SKEP III Home Office Support Site Visit Report

Consultant	Wahib Medanat Consultant Engineer	Rep No.	23-09042022
Contractor	Dijlah Establishment Constr. Contracting	Tender No.	(11/2019/USAID/SKEP/3/S) Schools for a Knowledge Economy Project (SKEP) - Phase (3) Package (1, 2)
Site Name	Jumana Bint Abit Taleb Basic Mixed School - Jerash	Day/ Date	Sat. 09/04/2022
Duration of Project	450 Calendar Days	Total Project Budget	8,314,983.735 JD

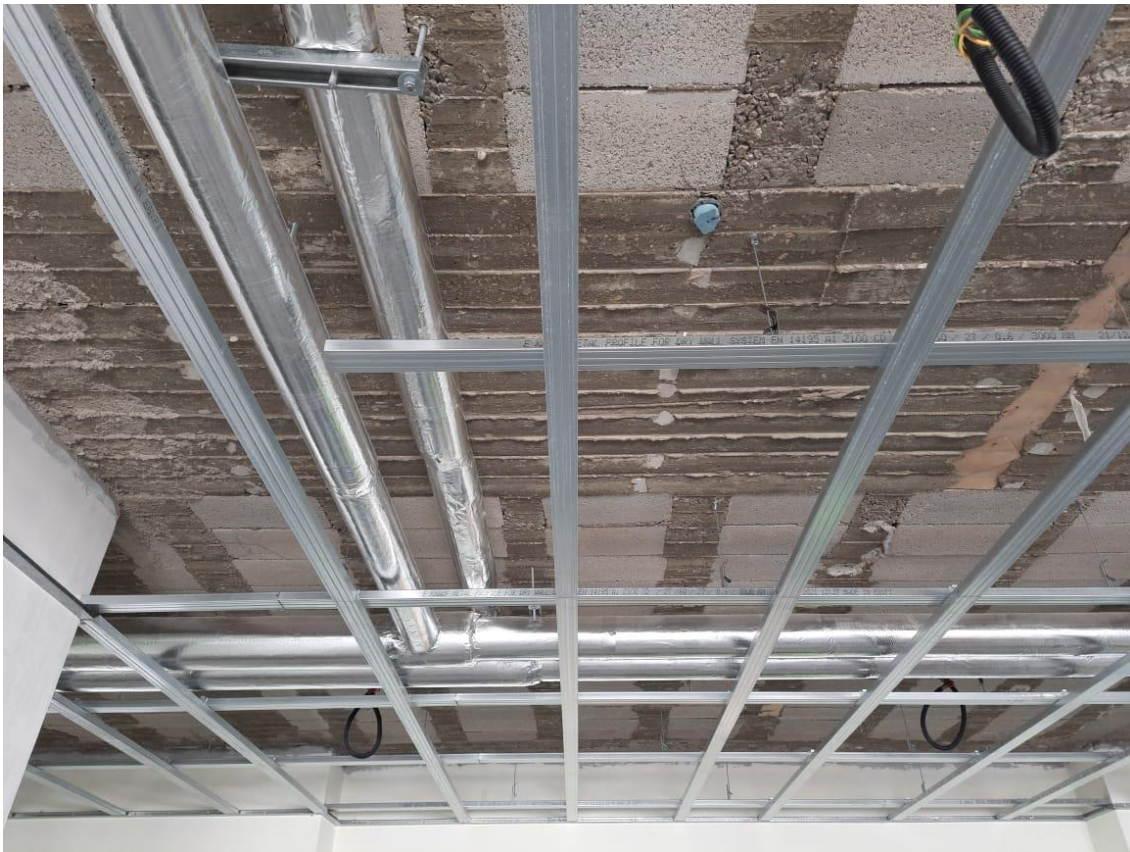
The team inspected the conducted repairs on the installed granite cladding for the staircases. The repairs are acceptable and the team requested the Contractor to replace just few broken pieces
